**Subject:** FW: Response to ARG's False Claims about CM Pool's Amendments to The Grove PUD  
**Attachments:** True Trips Table.pdf

**Agenda Item:** The Grove at Shoal Creek Planned Unit Development

## The Grove at Shoal Creek Planned Unit Development Parks Plan Exhibit

## The Grove PUD Erosion Assessment

□ Standards Analysis (Active Play Areas)

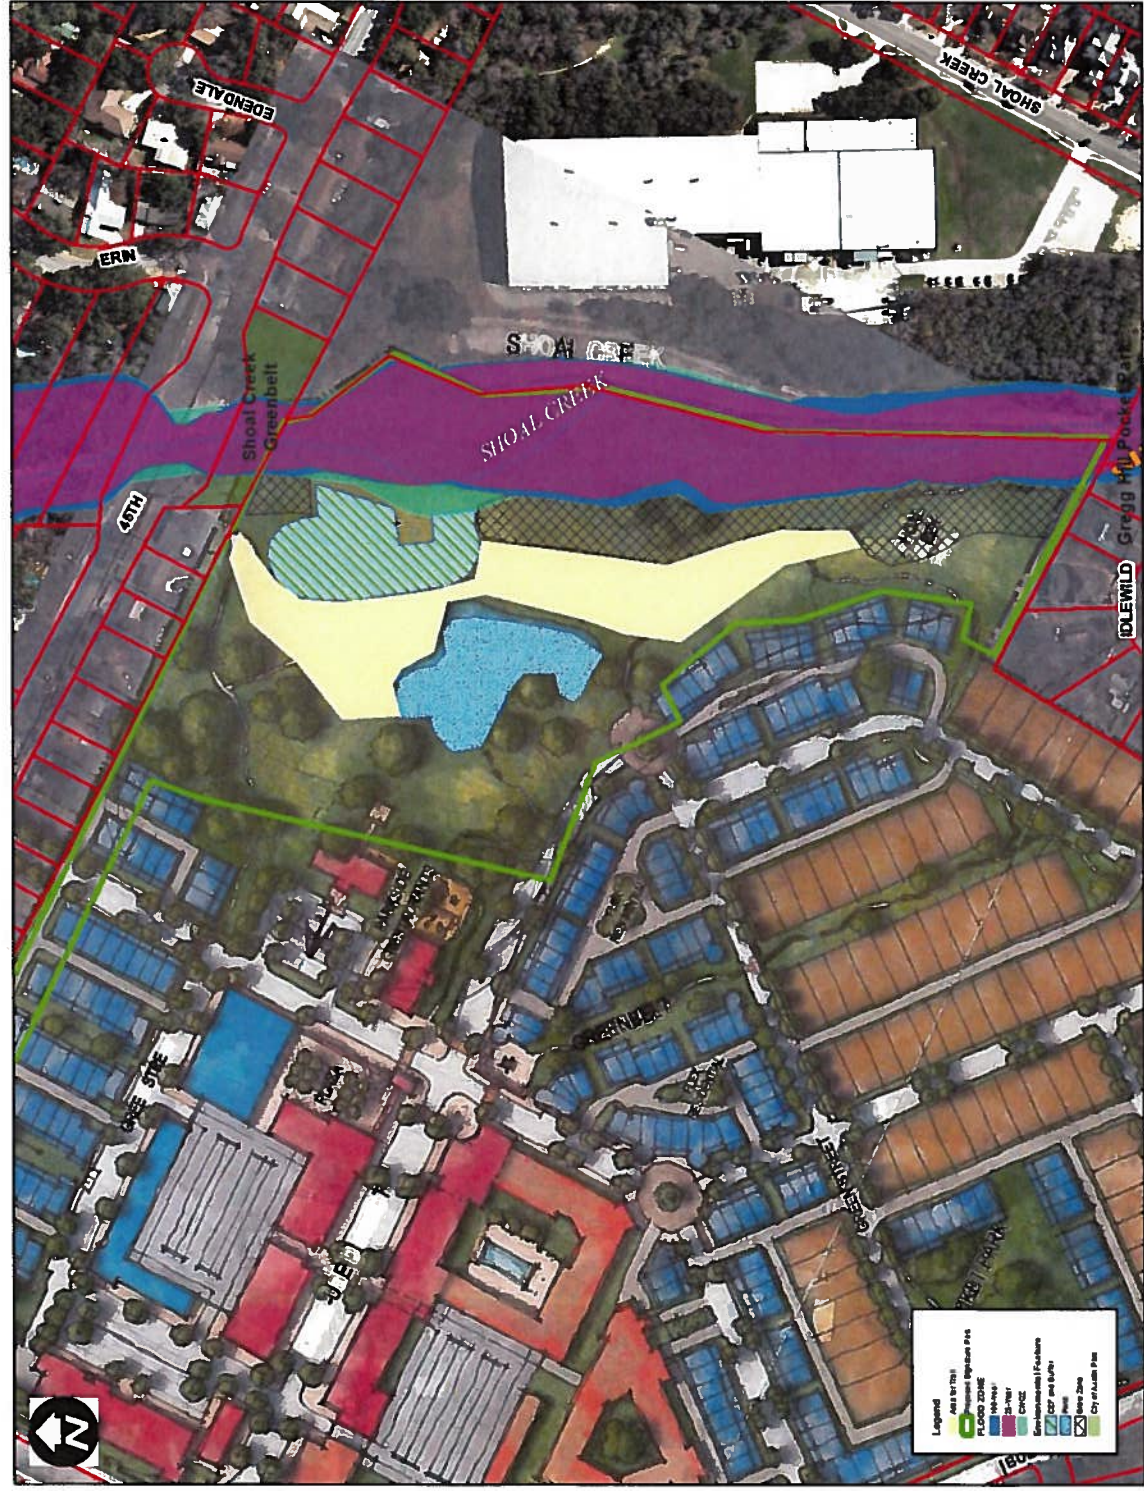
**Rationale for frontage and acreage needed to provide the frontage:**

- The development along the frontage of most of the Signature Park will hide the park amenities, much as the playscape at Central Market and the Arboreteum cow sculptures are hidden from street view at those developments today. Those are not parkland. They provide an example of how we feel the Applicant's configuration will not address the public realm.

- We need street frontage for superiority, regardless of how much acreage is owed. To this end, we would change Note 8 on the June 7, 2016 Park Exhibit that state: " the signature park should have a minimum of 400 feet of total street frontage" to " the signature park should have a minimum of 1,100 feet of total street frontage." Also see the attached graphic that extends the proposed park space outside of floodplain to show the street frontage.

**No Credit  
for 25- Year  
Floodplain  
= 10.68 Acres**

□ Acreage Credits – Signature Park (13.88 acres)

Half Credit  
for 100 -  
Year  
Floodplain  
= 10.56 Acres

No credit for  
CEF, CWQZ  
and 1/2 of  
Pond

**= 8.88 Acres**

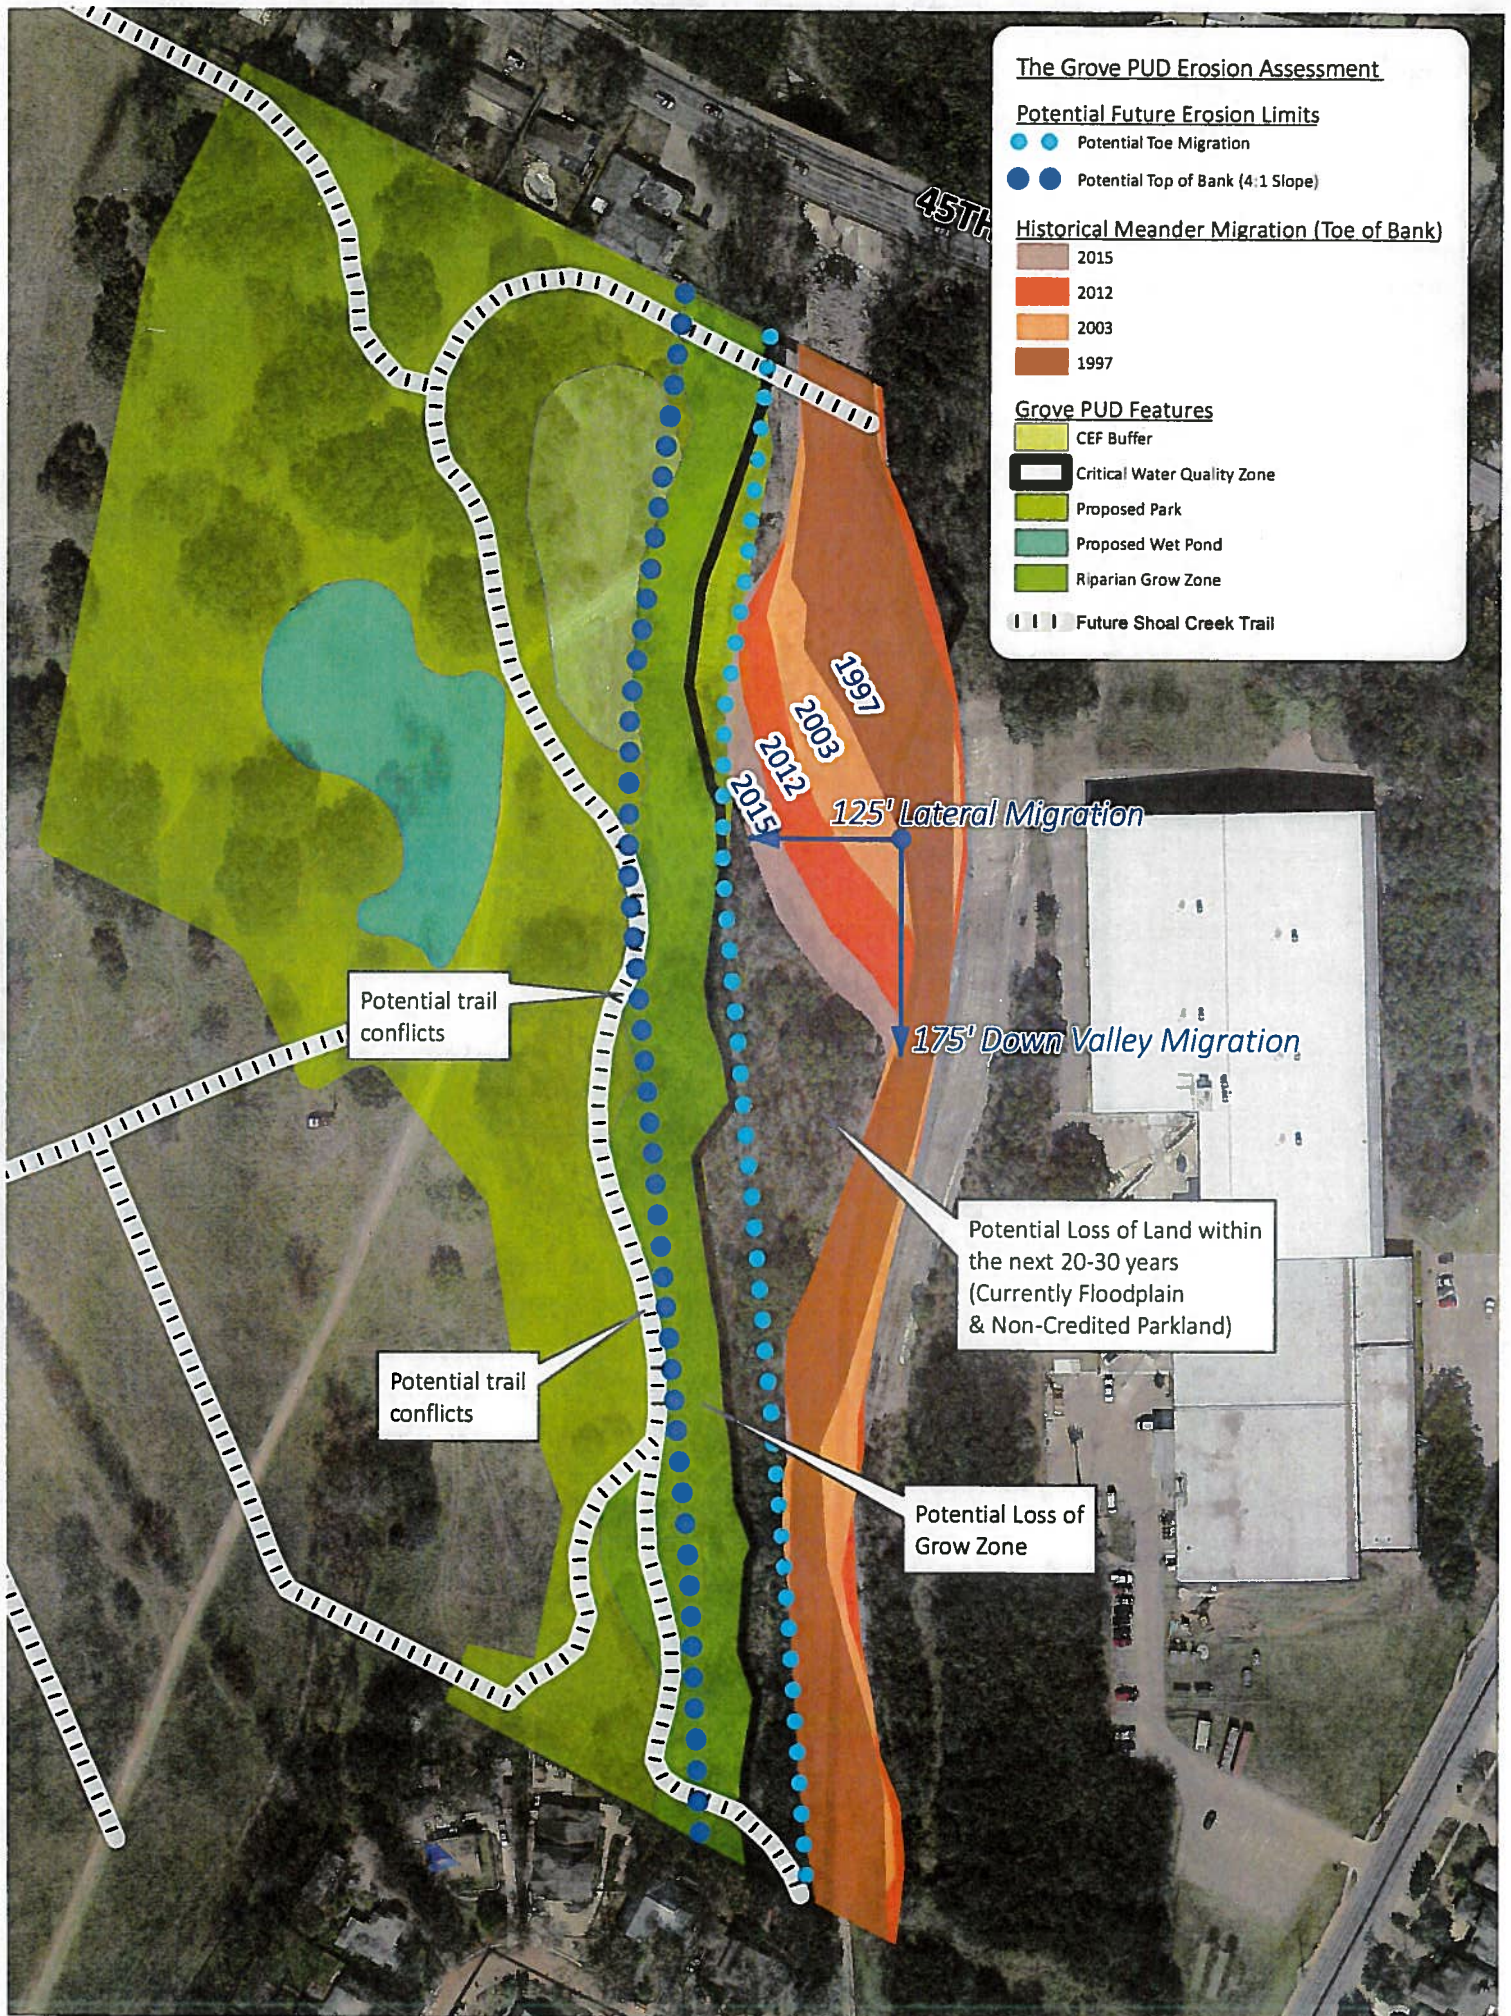
While it is difficult to precisely predict the evolution of urban streams that are highly impacted by the built environment, the erosion does show a consistent pattern of downstream migration – approximately 175' in 18 years. It is reasonable to assume that this pattern will continue as shown in the attached map, with the rate of movement dependent upon storm events. The downstream migration is expected to taper off as the stream reaches a pattern that mimics the historically stable downstream conditions. It is also reasonable to believe that the erosion will stabilize as the influence of the bridge hydraulics lessens further downstream.

The attached map shows two blue dotted lines that show the predicted toe of slope (light blue) and top of bank (dark blue).
